**Lands at Gortnahomna,
Castlemartyr, Co. Cork**

Infrastructure Design Report
(Planning Submission)

2411-DOB-XX-SI-RP-C-0001-S2.P04

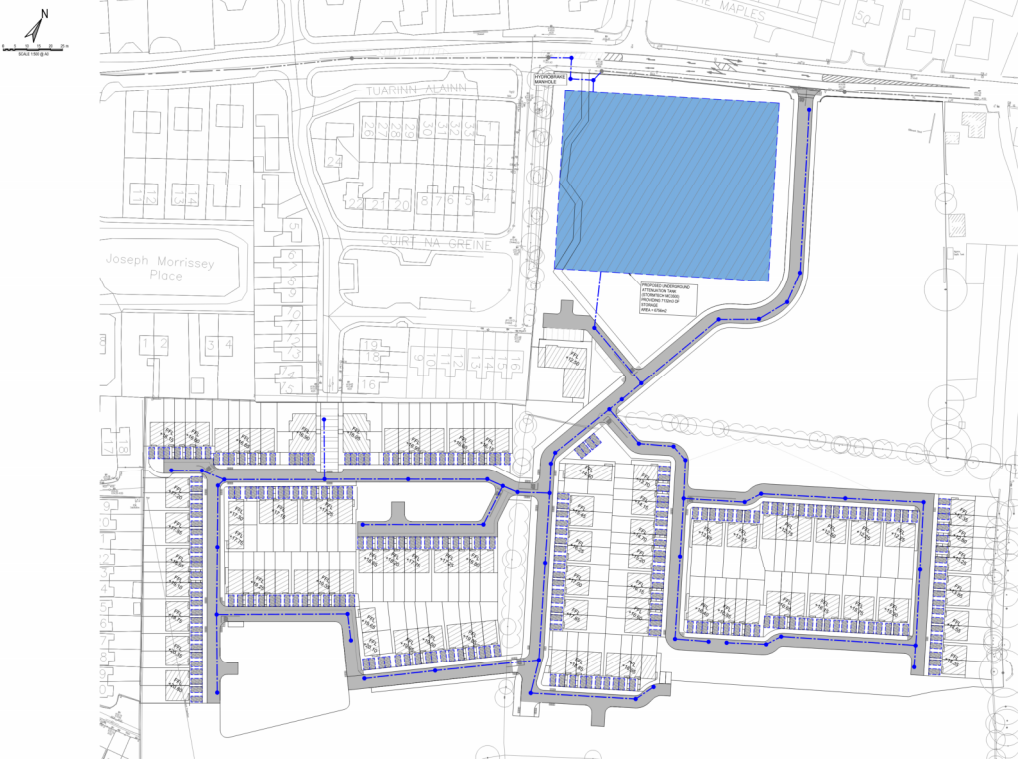
Cork County Council Water Services Department Section s247 Meeting Comments	Applicant's Response
Why is the attenuation not all provided in one area adjacent to the SW outfall?	A SuDS treatment train has been provided in accordance with GDSDS as illustrated on drawing C-0200. This approach addresses both runoff quantity and quality and allows for smaller pipe sizes to be designed through the site by utilising sub-catchments with associated SuDS features and attenuation. The proposed surface water network and attenuation design has been designed to facilitate the application development site and also future development to the north and south of the application site. Providing only a single attenuation system at the outfall would result in an extremely large attenuation tank (ca. 7,000 m³) and would restrict the available lands for development in the northern portion of the site – see below an image of the attenuation tank required. The volume of attenuation required for a single attenuation tank is significantly greater than the overall attenuation volume for the treatment train approach (2,223 m³).

Figure 5 Extents of attenuation at outfall for a single tank
An assessment of the existing surface water network along the N25 is required to confirm available capacity to receive flows from the proposed development, including CCTV survey to confirm condition of the network,	Refer to the Drainage Impact Assessment prepared by DOBA and submitted with the planning application. In summary, the proposed flows entering the existing surface water network along the N25 are to be restricted to less than the existing flows entering the network. As such, additional capacity is being created in the downstream network due to the proposed SW design.
Rainfall on the site discharges to ground at present.	As noted in Section 4.4 of the IDR, soakaways in accordance with the BRE Digest 365 have
